**S16 Planning Application for
Proposed Composite Redevelopment with Residential, Commercial and Trade Mart,
Social Welfare Facilities and School uses and Minor Relaxation of Building Height Restriction
at New Kowloon Inland Lot No. 6032, 1 Trademart Drive, Kowloon Bay, Kowloon**

(S16 Planning Application No. A/K22/37)

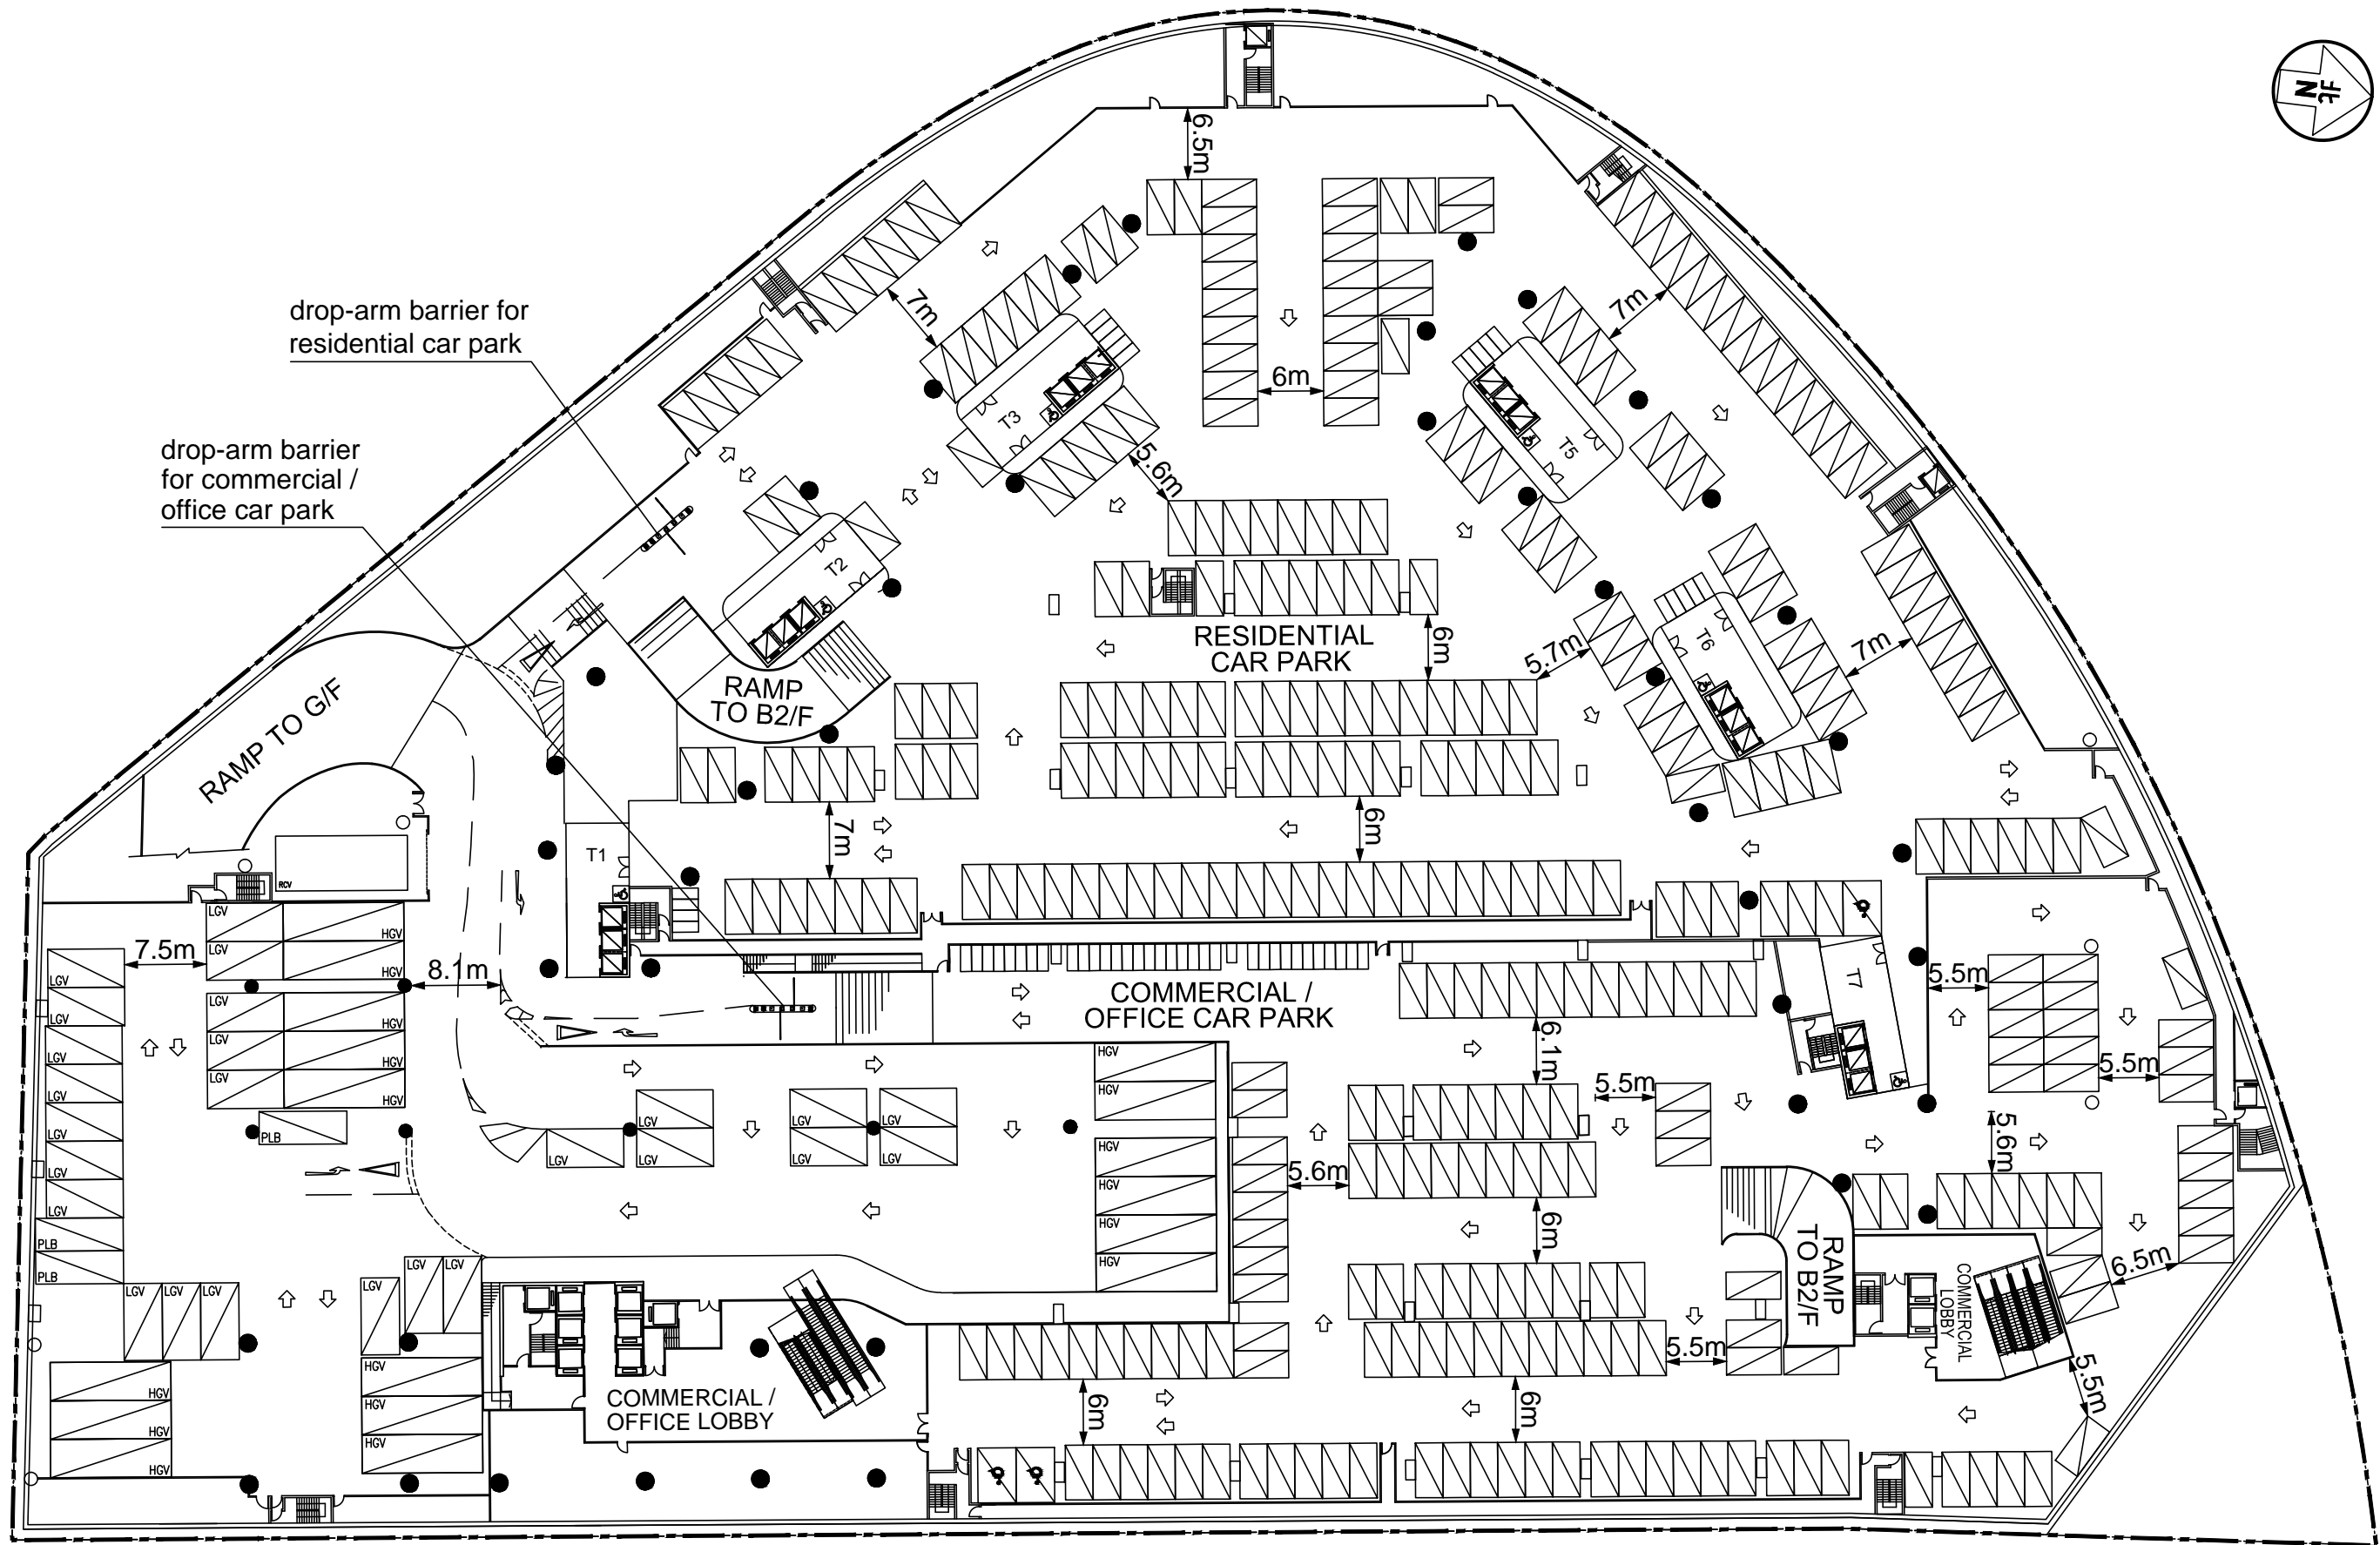
1.5	<p>General Please mark the "Brown Area" on the layout plan to show its extent.</p>	<p>The extent of Brown Area is shown in Figure 3.1 of the revised TIA report (Annex 1 refers).</p>
Comments on Appendix 2 - Traffic Impact Assessment Final Report

1.17	<p>Figure 3.1 It is noted that the accesses of "ramp to 1 /F", "ramp to B 1 /F" and taxi layby are in close proximity.</p> <p>In view of level difference, the drivers leaving the "ramp to 1/F" may not have sufficient sightline to view the vehicles leaving the "ramp to B1/F". Please review and provide necessary traffic measures to improve the road safety at the concerned location.</p> <p>To improve the pedestrian connectivity of the existing bus stop at Kai Fuk Road and the proposed redevelopment, please advise if there would be a proposed pedestrian crossing at the markup location in Annex B.</p>	<p>As shown in Figure 3.1 of the revised TIA report, the up-ramp to 1/F has been shifted further from the run-in / out by around 8m. In addition, the fence wall in between the two adjoining driveways has been removed and the sightline of motorists leaving 1/F is improved.</p> <p>A standard cautionary crossing (i.e. with drop kerbs and tactile warning strips) at Trademart Drive outside the proposed run-in / out will be constructed by the Applicant as part of the Proposed Redevelopment.</p>
